# **Technical Document LA25055A**

Application for Amendment

Application under the Agricultural Operation Practices Act to amend a permit for a confined feeding operation, manure collection area and/or manure storage facility(ies). ("Permit" means an NRCB-issued or grandfathered approval, registration, or authorization, including a grandfathered municipal development permit.)

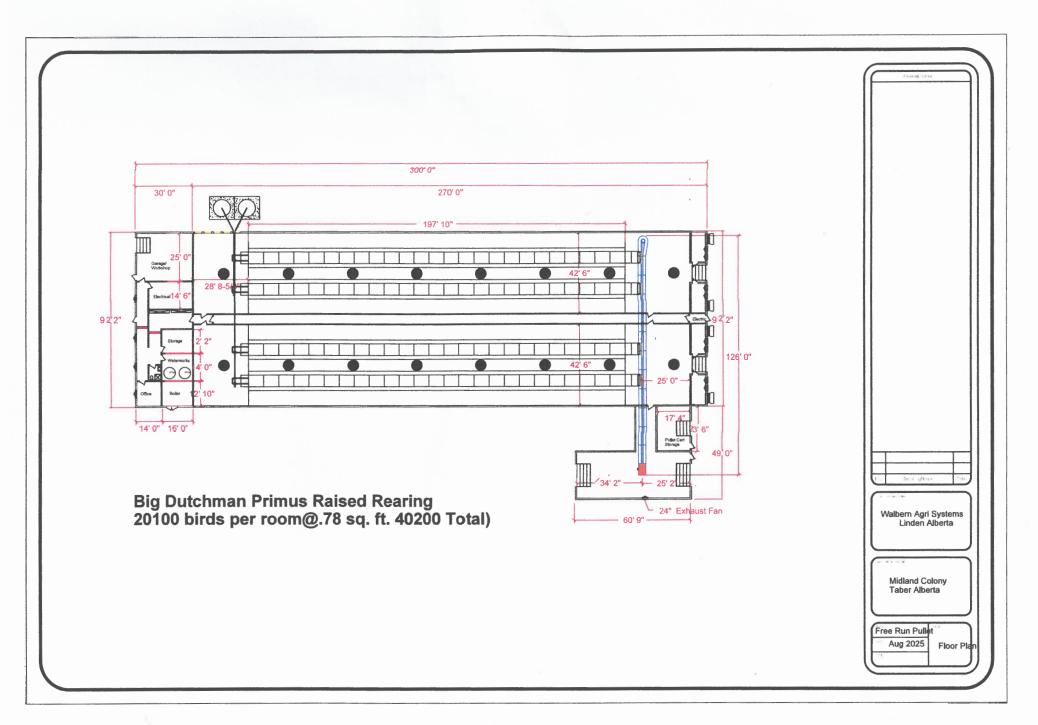
Barn size was changed, to acommodate equipment, and location

AO Comment: Applicant is applying to amend the pullet barn from the permitted dimensions of 91.5 m x 25.6 m to 82.3 m x 28.1 m. The dimensions of the attached manure storage room are to remain the same at 18.5 m x 14.9 m. The office attached to the pullet barn, which is an ancillary structure, is also changing dimensions from 12.2 m x 25.6 m to 9.2 m x 28.1 m.
